Official Transcript of Proceedings  
NUCLEAR REGULATORY COMMISSION

Title: Advisory Committee on Reactor Safeguards  
ESBWR Subcommittee

Date: Tuesday, November 17, 2009

# RAI 6.2-139 -Corrected

Figure 9. NC Gas Pressures in DW Annulus, DW Head and GDCS Gas Space

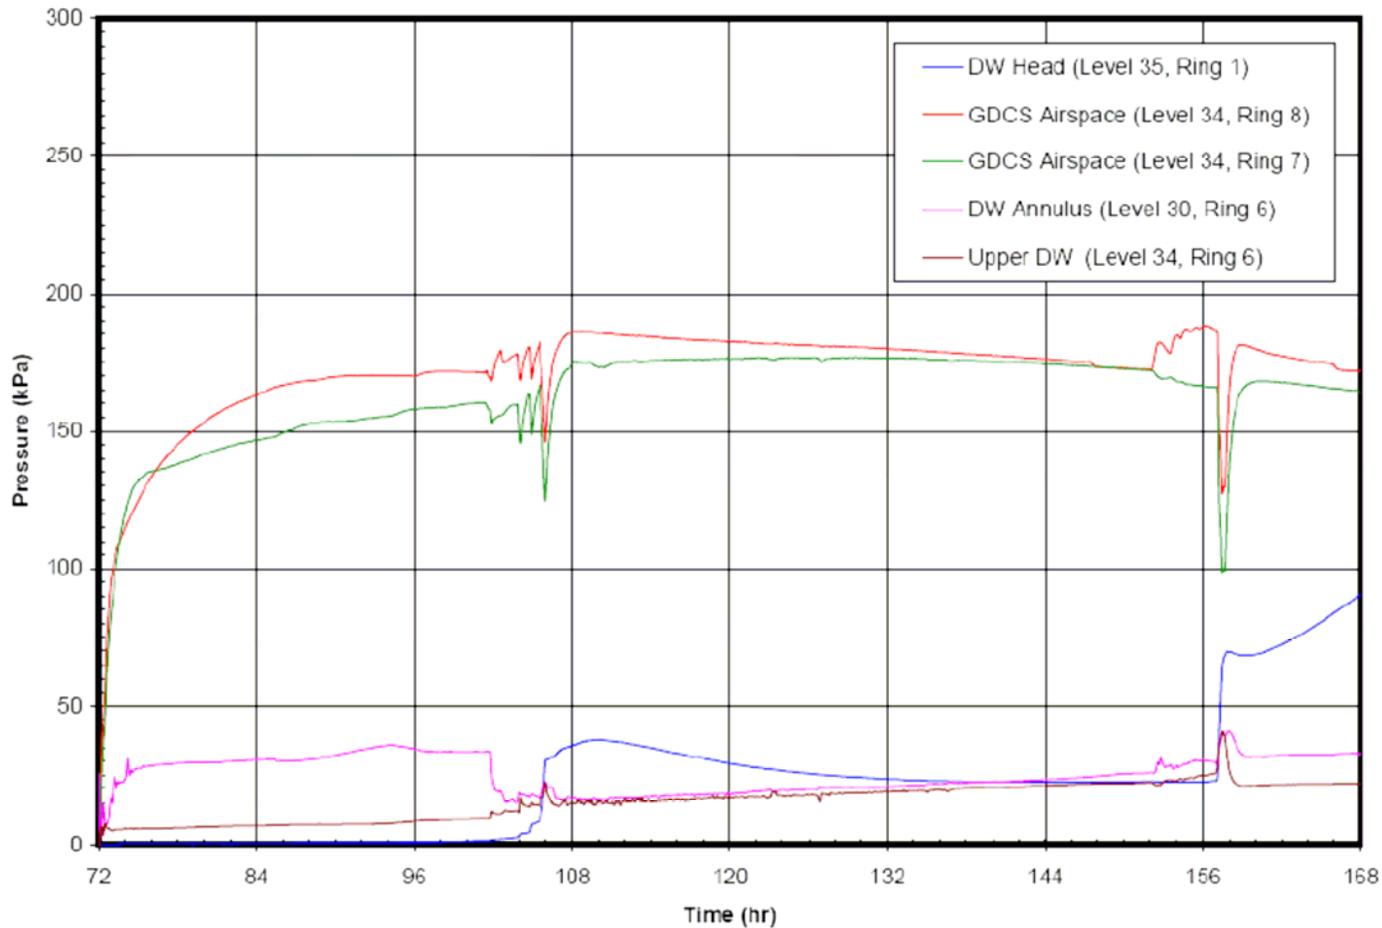
22 One of the ACRS consultants noted an  
23 error in the plot of noncondensable gas pressure, an  
24 RAI response. The upper drywell, which is Level 34,  
25 Ring 6 had been plotted as zero noncondensable

20 CONSULTANT WALLIS: Level 34; I had a lot  
21 of trouble figuring out where it is. It's not labeled  
22 in one of your figures you showed in July. And as  
23 this is drawn, it seemed to be at the top of the RPV,  
24 which is actually way up in the head. It doesn't  
25 make sense to me. So part of my question at that time

4 CONSULTANT WALLIS: That's why I didn't  
5 understand where the gas came from at 104 hours, or  
6 something. There's a big squirt of gas into the  
7 drywell head. There's no gas in the drywell head at  
8 all until about 100 and something hours, isn't that  
9 correct? That curve that you've now corrected or is  
10 it in there?

1 big surge. It must be driven by pressure or  
2 something. I mean, in later figures it doesn't  
3 appear. This is an old figure. If you look at newer  
4 figures, that's not there. I think it's the old  
5 history of flashing in the pool.

1 partial pressure. And we've corrected that plot and  
2 provided a revised RAI response to the staff.

## Level 34, Ring 6 curve on Figure 9

Figure 6.2-140 S04-C1 Main Steam Line Break, 1 DPV Failure (Bounding Case) – Containment Pressures (30 days)

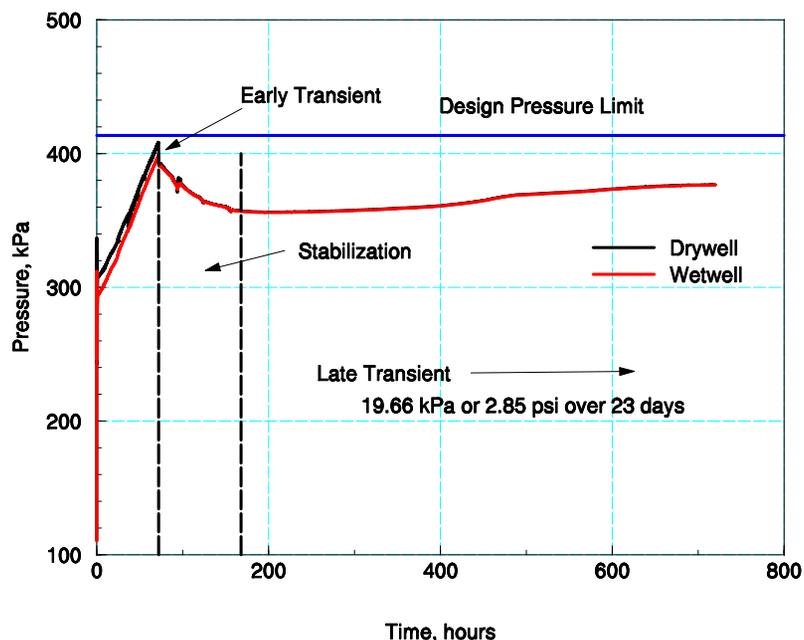
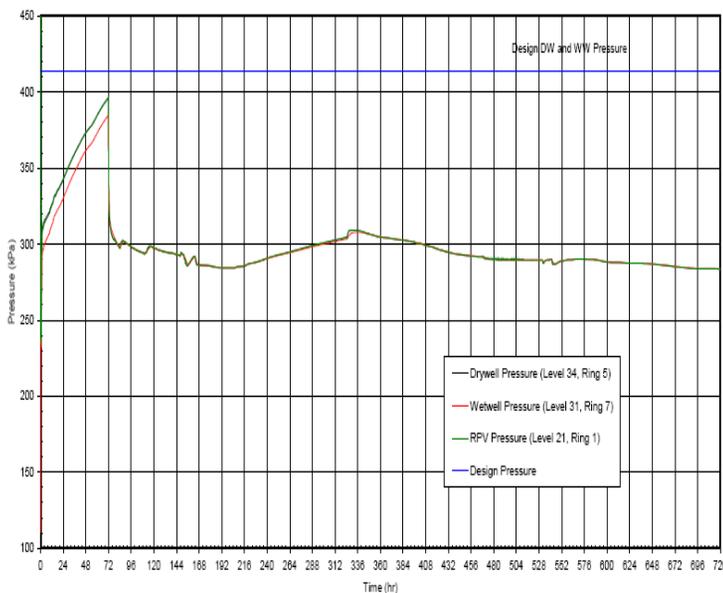
4 And so I think at least to start with, I  
5 want to understand -- to get back to Graham's  
6 original question what's happening at 104 hours and  
7 158 hours that caused this oscillation. Can anybody  
8 on the phone line answer that?

14 CONSULTANT WALLIS: That shows none of  
15 these wiggles. Excuse me. That figure shows none of  
16 these wiggles, the one you just cited. So I assume  
17 the wiggles have gone away.

2 CONSULTANT WALLIS: And I think in the  
3 new one there are none of these wiggles we were  
4 talking about. So something has happened in the  
5 analyses or something to make the wiggles go away. I  
6 think it would be nice to have an explanation of what  
7 they were and why they went away.

4 MR. MARQUINO: Yes, the pressure response  
5 of this figure is superseded by the 6.2-140 figure in  
6 DCD Rev 6 figure.

6 The figure that we sent to NRC for 6.2-  
7 140 S05-C4 is the latest and it has the corresponding  
8 noncondensable pressures in the drywell and GDSC  
9 airspace.
